P & Z File No. 5-81-~~32~~

RE: NICHOLS PROP

Nichols Property Sketch Plan

SKETCH PLAN
NICHOLS PROPERTY
TAX MAPS 28 & 34 PARCEL 1
5th Election District
Howard County, Maryland

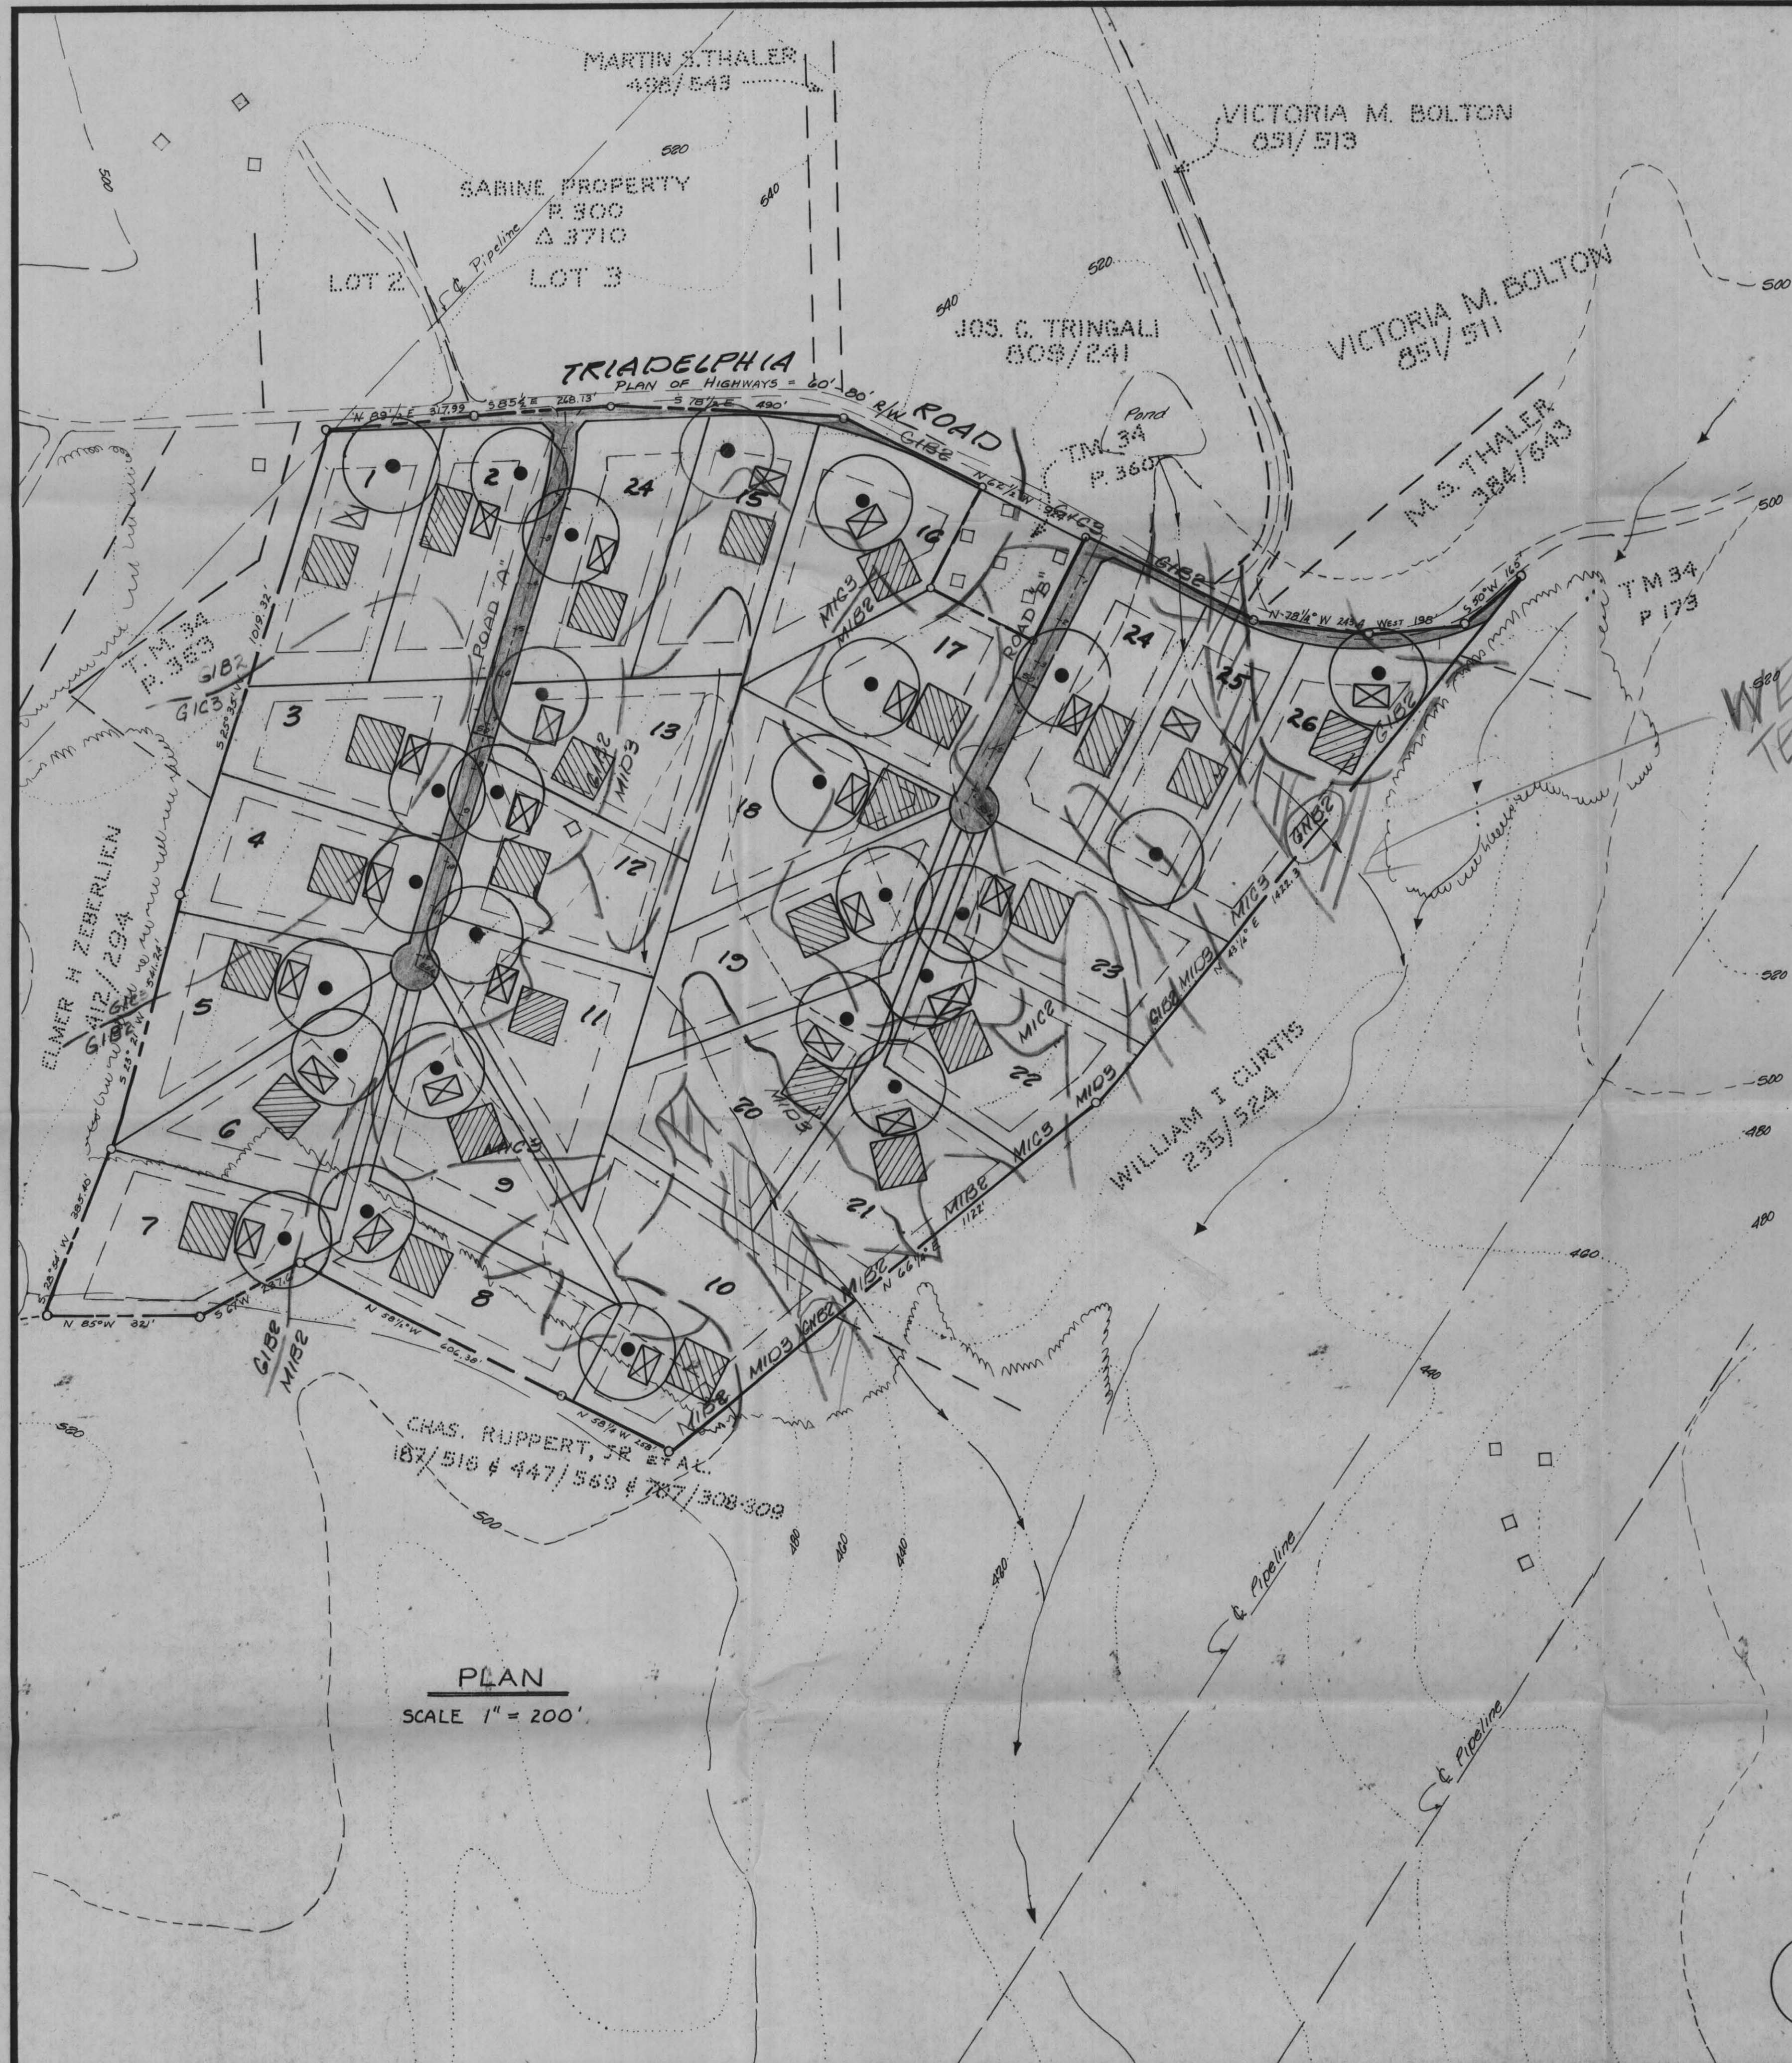
Prior to our review & comments a sketch plan with 2 foot contour is required; no percolation test application can be accepted without it.
